FILE #SPR-95-87

TITLE HEADING: Site Plan Review - Golden Corral  
Restaurant

LOCATION: Faith Street & Independent Avenue

**BIKE RACK**  
1/2" = 1'-0"

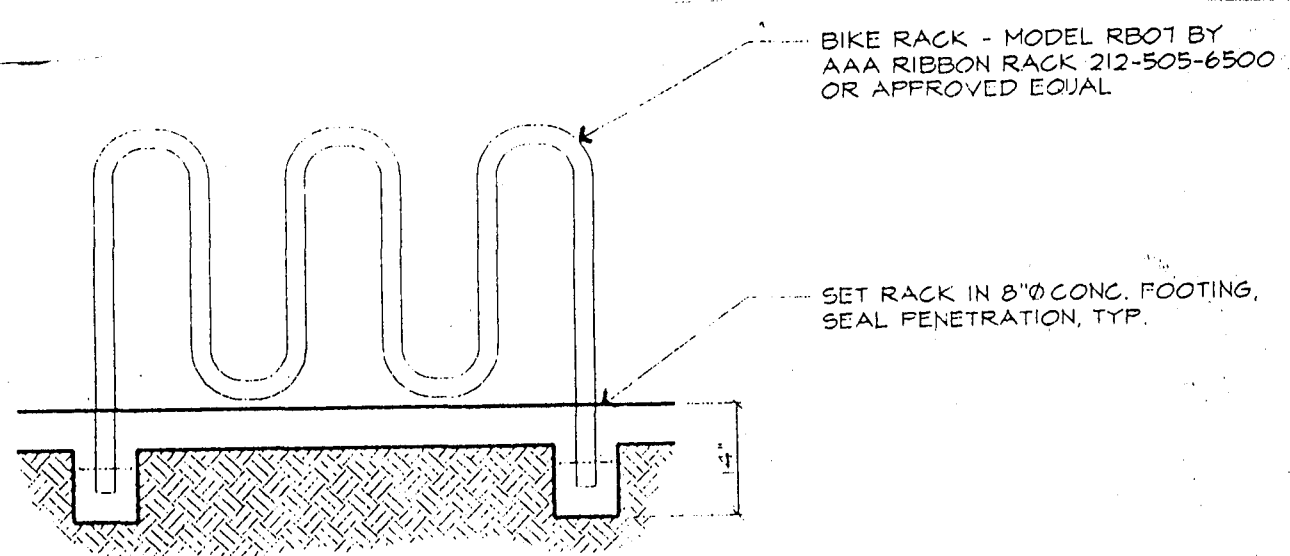
2. Bicycle parking has not been provided as per Code. Please see attached Code requirement and bicycle rack detail (or equivalent) which must be shown on plans.

## LANDSCAPE PLAN GOLDEN CORRAL RESTAURANT GRAND JUNCTION, COLORADO SCALE 1" = 20' Ø

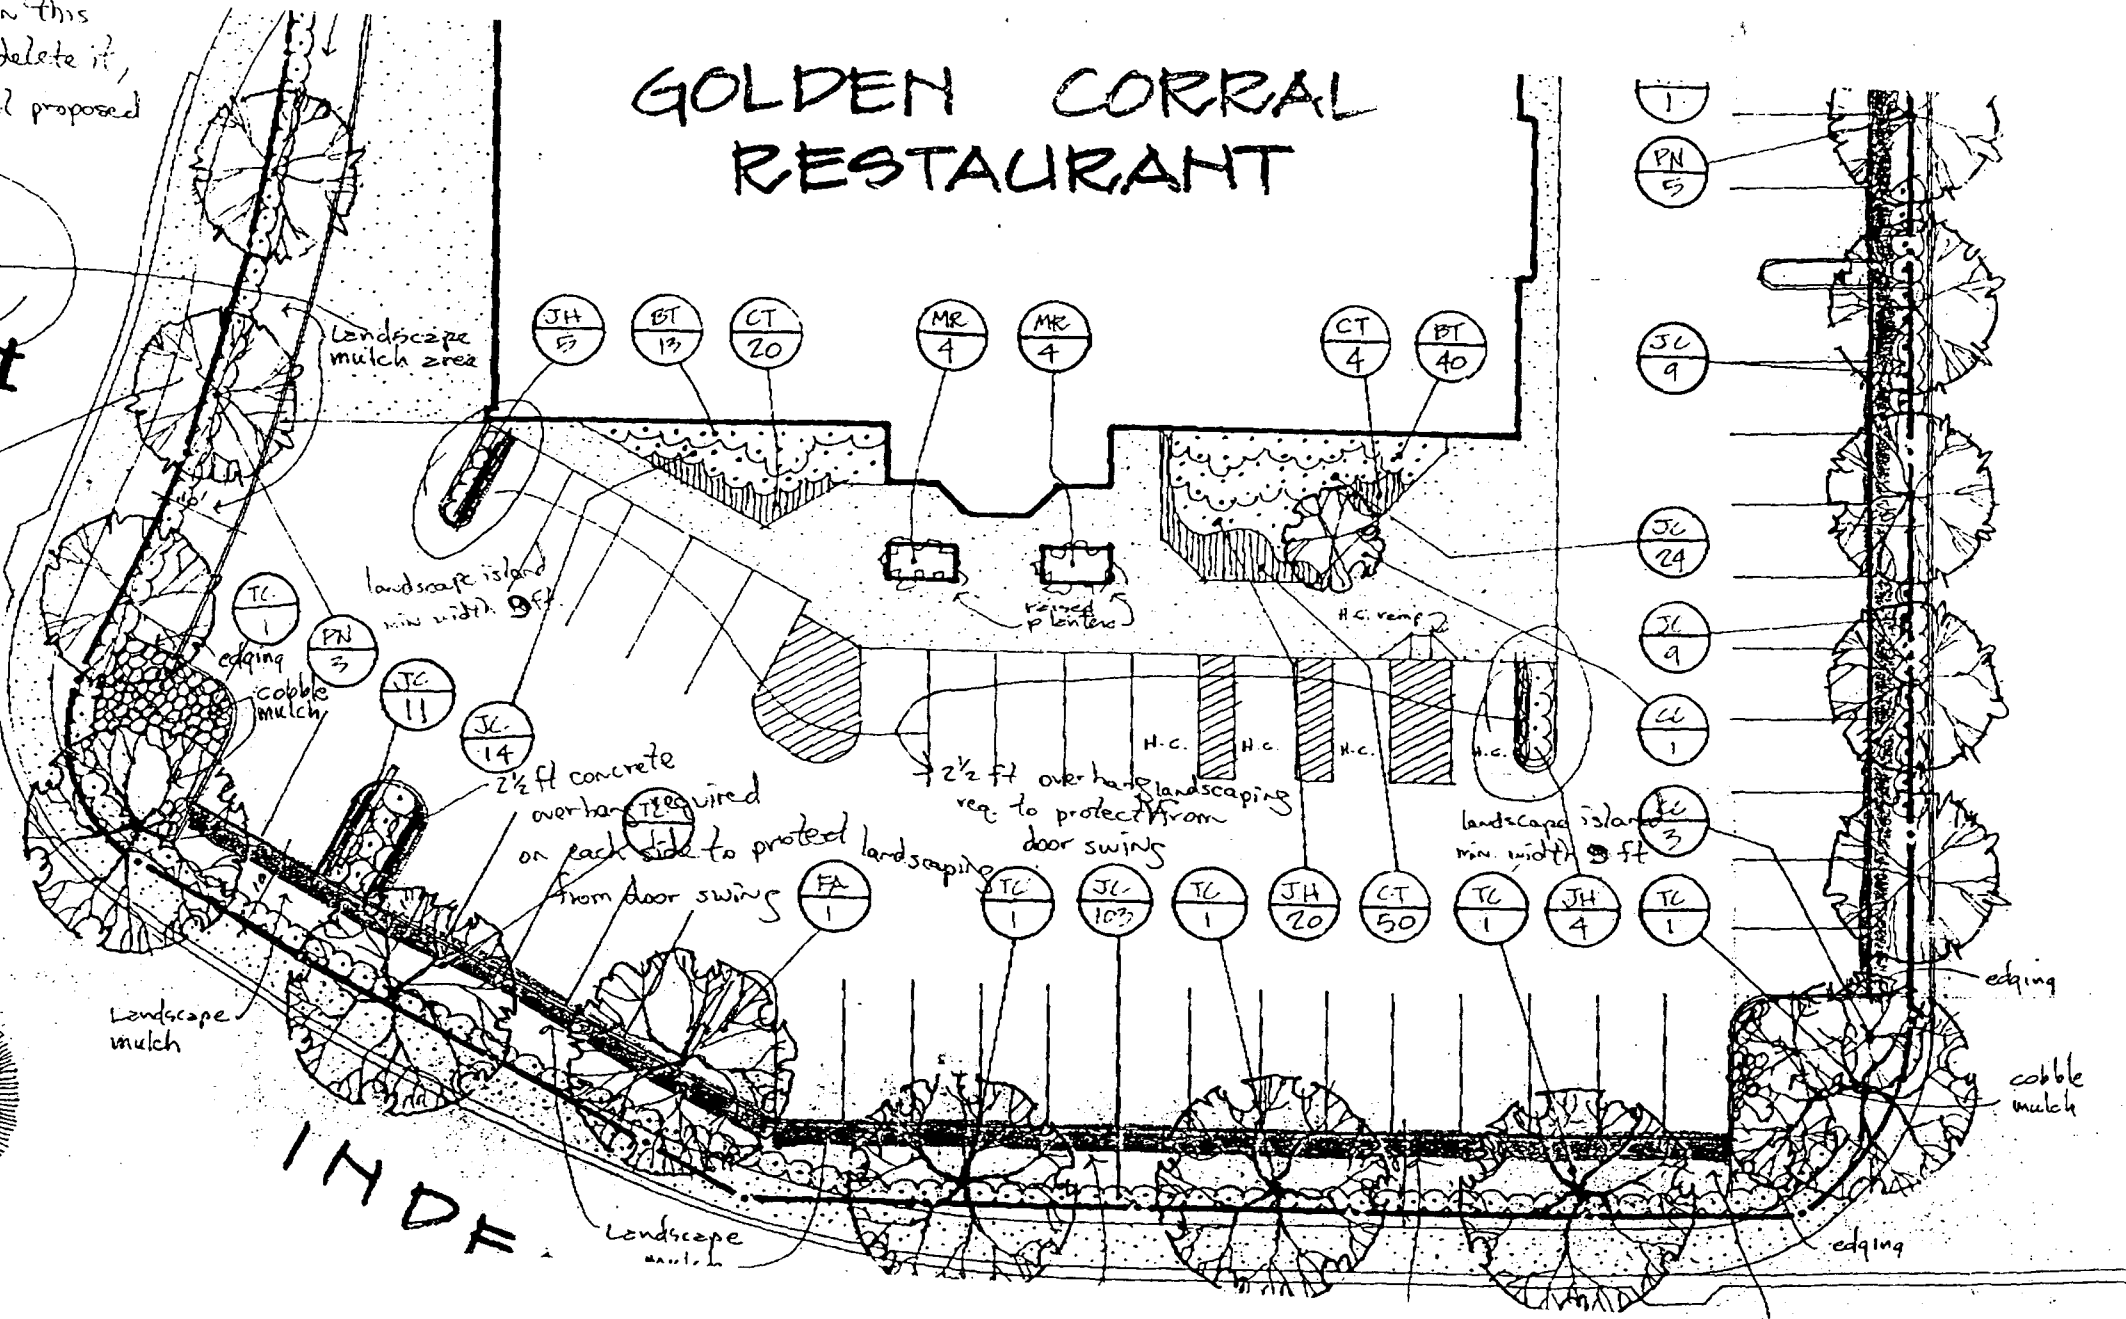
The "Site and Grading Plan" and the "Landscape Plan" contain a number of inconsistencies - e.g. the parking which was eliminated on the Site Plan must also be taken off on the Landscape Plan; landscaping is shown on a parking island along the eastern property line on the Landscape Plan but is shown as a concrete slab on the Site and Grading Plan. Also, the Landscape Plan indicates shrubs to be planted along the rear of the restaurant where the Site and Grading Plan shows concrete ramps and is not clear as to where the planting bed could be accommodated. Please review your plans in detail and correct any inconsistencies between the plans.

Landscaping was OK in this area; if you want to delete it, please indicate material proposed

landscaping OK in this area, if you want to delete it, please indicate material proposed

Issue 3: Inconsistencies among the site development drawings have been cleaned up. The landscape issues have been addressed as follows: the landscape buffer along the east property line has been increased to 5'; all landscape material has been deleted from the R.O.W. areas and no landscape materials will be placed outside of the Golden Corral property lines; a 10' landscape buffer has been provided at the southern and western property lines; landscape islands in the parking

area are revised to the  
required 9' per code  
(please note that the island  
along the east property line  
is a concrete access isle  
required by the FIRE  
MARSHALL).

**10 bike rack detail**

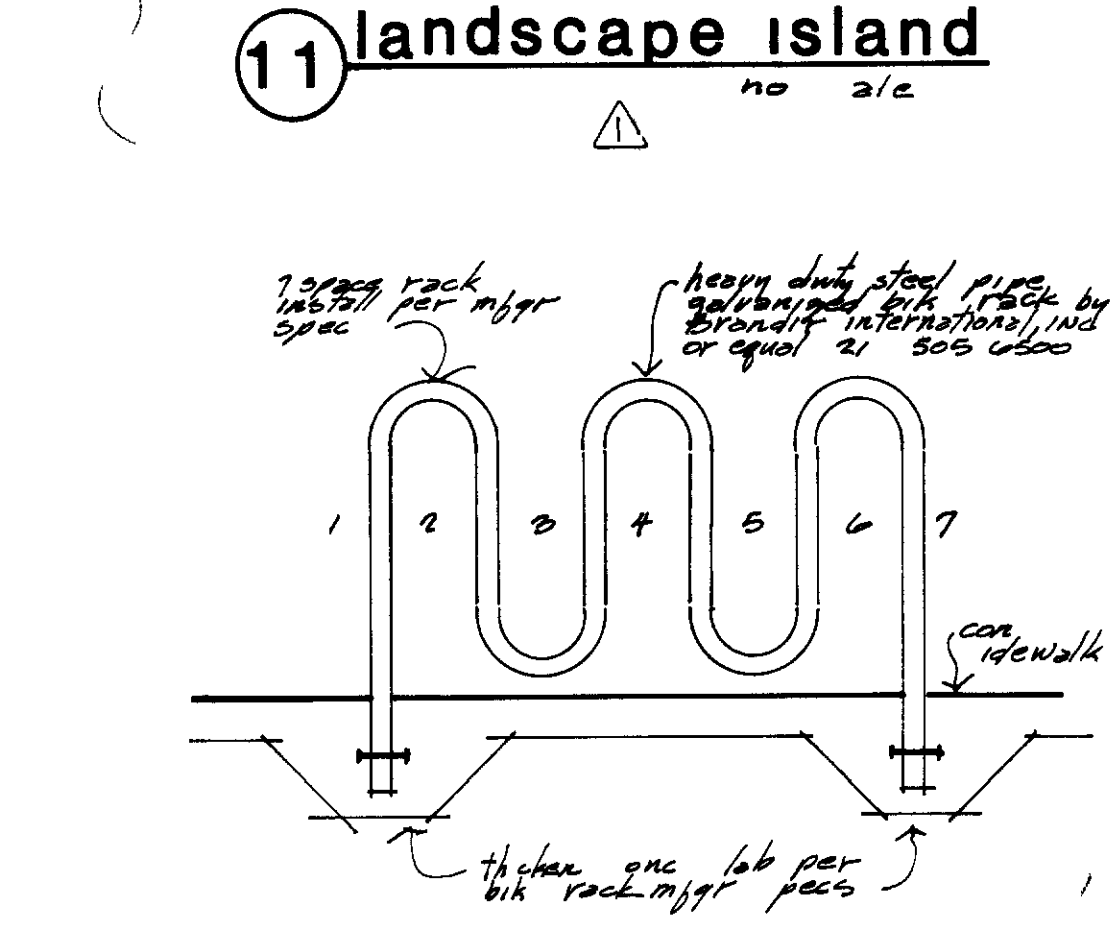
Issue 2: The bike rack location is shown on the architectural site plan sheet A1B and as detailed per 10A1B.

2. The bike rack is shown on the revised site and grading plan sheet C-1.
3. The fence or screen detail is per detail 9 - sheet A1B of the original submittal.
4. The two parking spaces at the west end of the parking area will be deleted to improve circulation.
5. We would prefer to maintain the drive isles "as is" to allow greater flexibility and maneuverability within the parking lot.
6. A revocable permit for landscaping within the R.O.W. is no problem.

**9 fence detail**

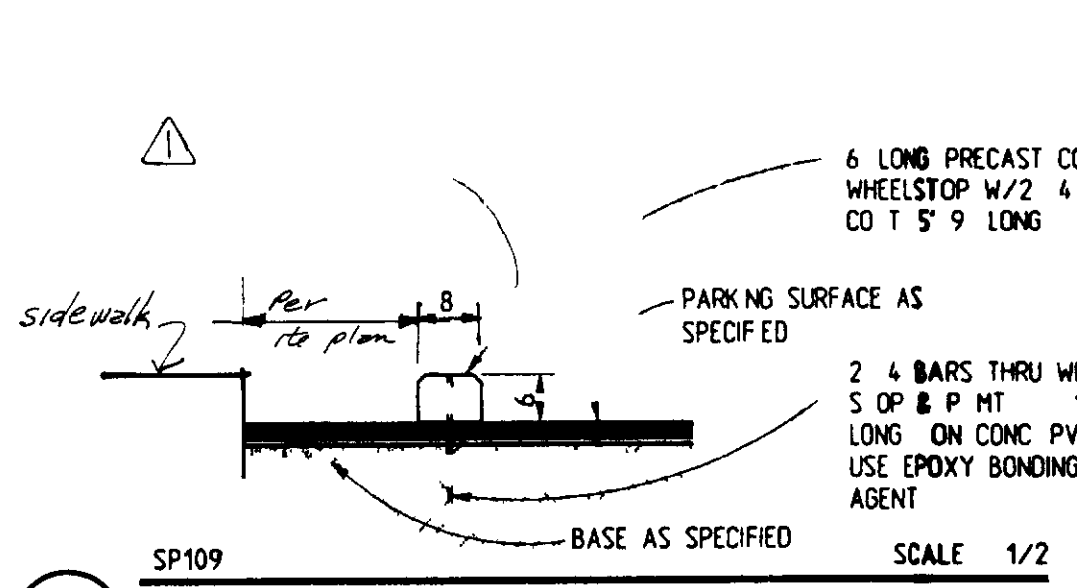
3. Please provide fence detail.
4. Parking lot circulation does not permit adequate turn-around at west end of lot. The last two (2) parking spaces must be removed to allow for adequate turn-around (see attached drawing).

**1 architectural site plan**

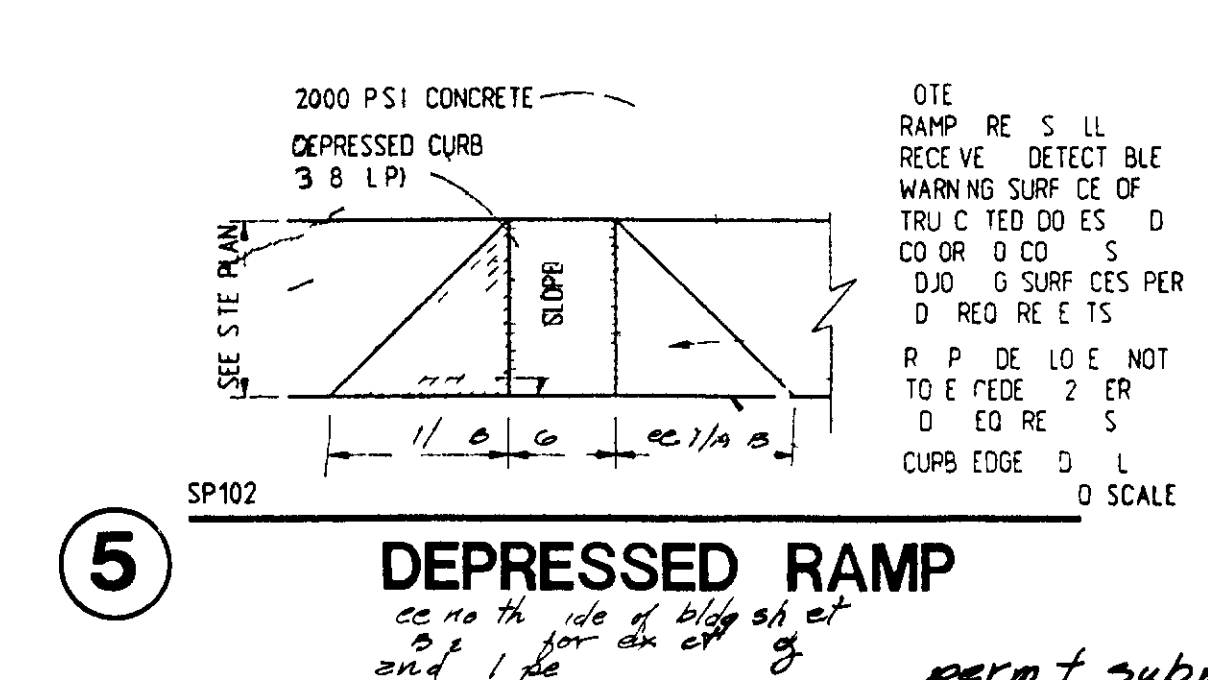
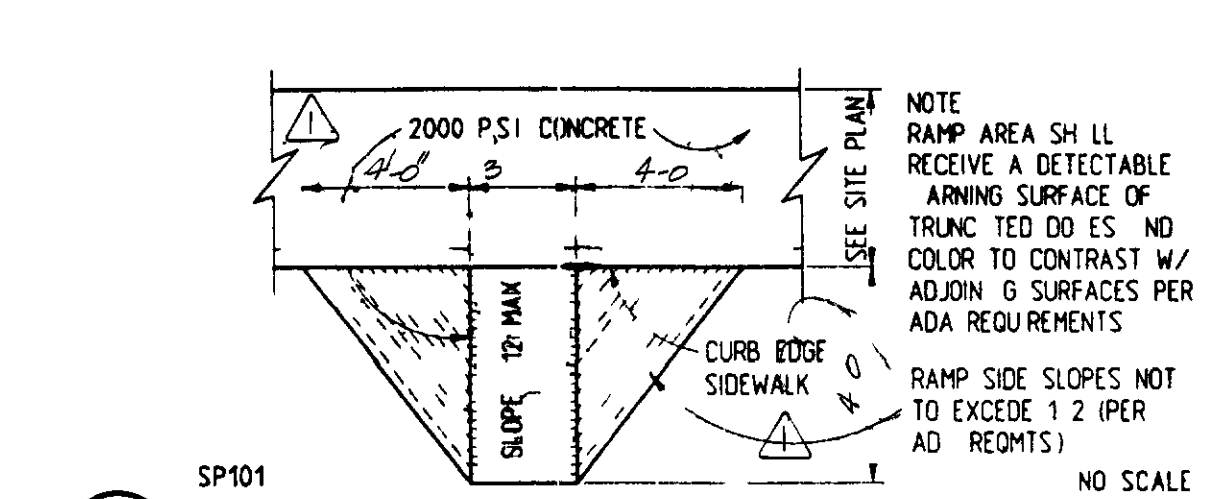
issue #1: The architectural site plan  
sheet A1B shows the property  
lines in a heavy line with the  
bearings and property line  
dimensions shown adjacent  
to the heavy line. Additional  
information regarding property  
lines is shown on the A.L.T.A.  
survey sheet A1A (previously  
provided). The property lines  
on the A.L.T.A. are also

shown with a heavy line with bearings and property line dimensions shown adjacent.
